## WISCONSIN PUBLIC SERVICE CORPORATION

Docket 50-305  
Operating License DPR-43  
Kewaunee Reload Safety Evaluation Cycle 4

Enclosed you will find forty (40) copies of the following attachments submitted in support of our application for Amendment to the Technical Specifications concerning the operation of Cycle 4 of the Kewaunee Nuclear Power Plant.

FIGURE 1

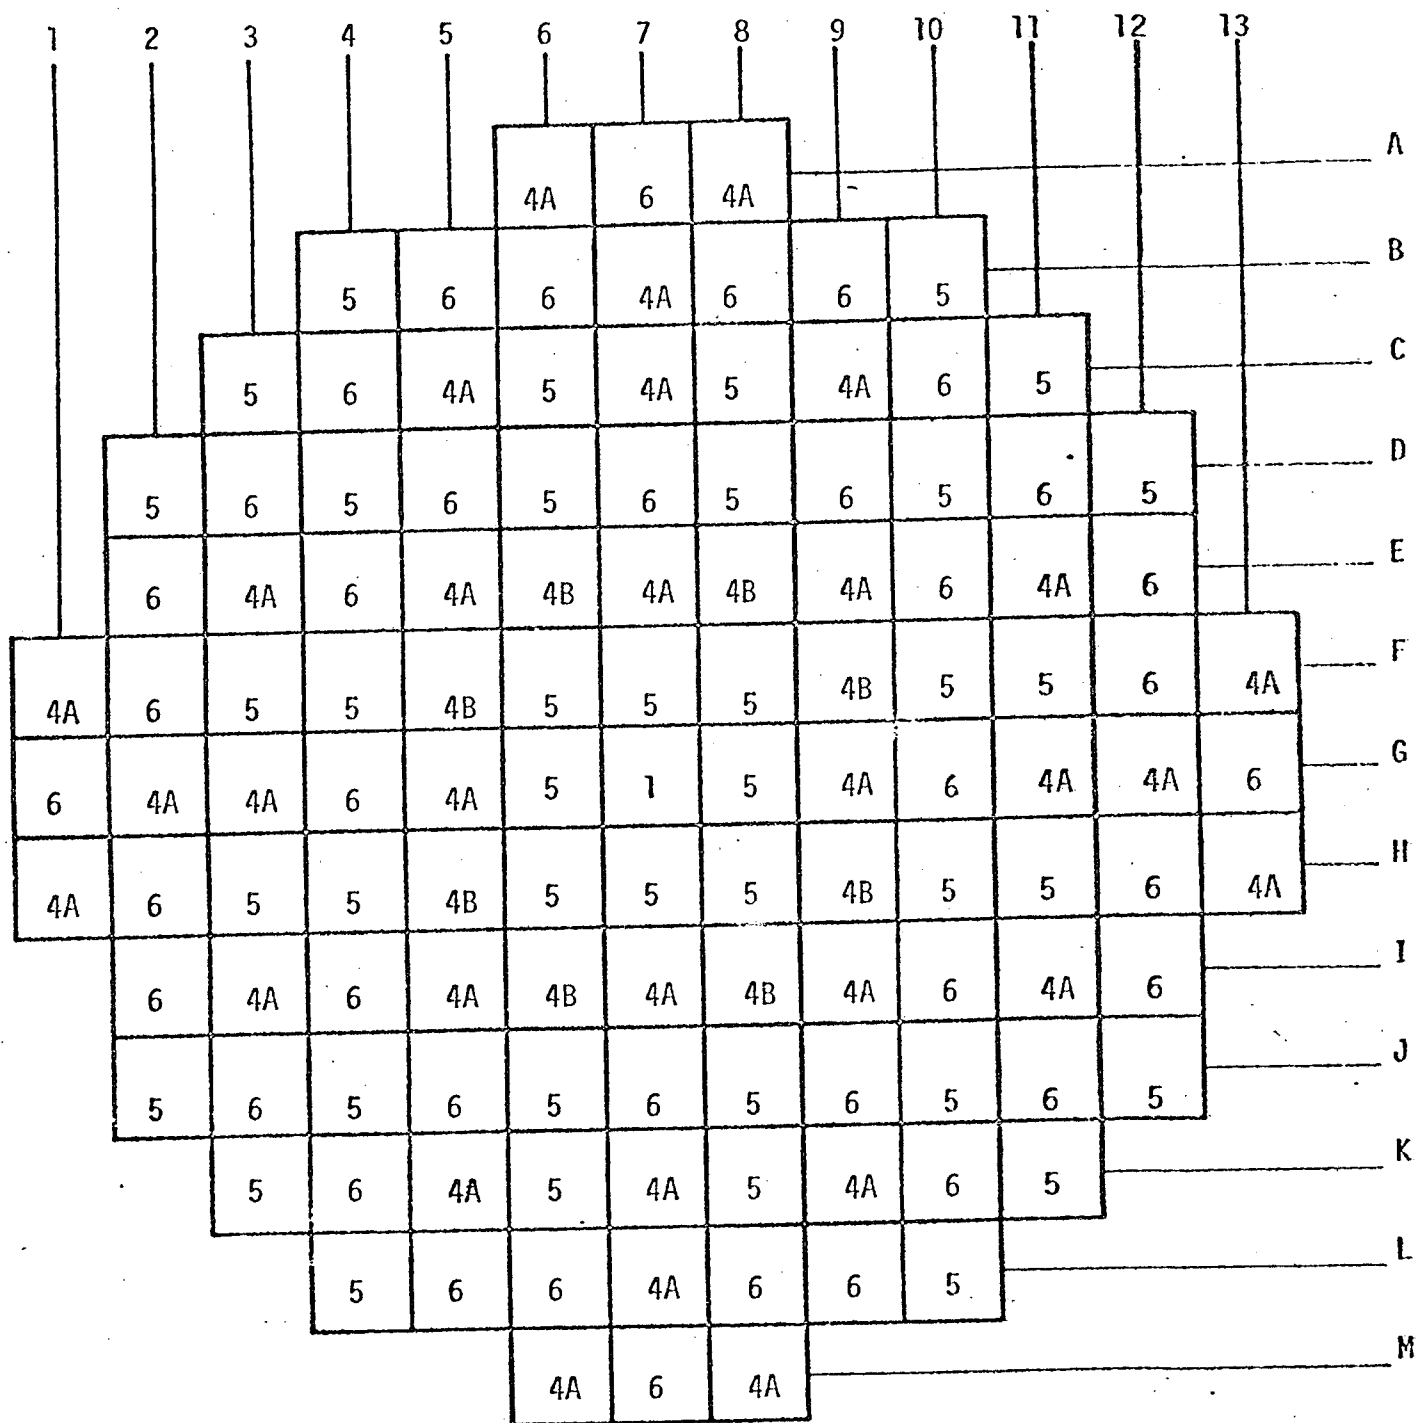
- (1) Figure 1, page 15, of the RSE for Cycle 4 has a typographical error in it. Please insert the attached page in place of the existing page and destroy the removed page.
- (2) Attachment No. 2 provides a listing of the currently planned Physics/Startup Tests to be performed for Cycle 4 along with the acceptance criteria for each test.
- (3) Attachment No. 3 contains the response to those questions transmitted by the referenced letter concerning the RSE for Cycle 4 submitted as supplemental information in our application for change to the Technical Specifications.
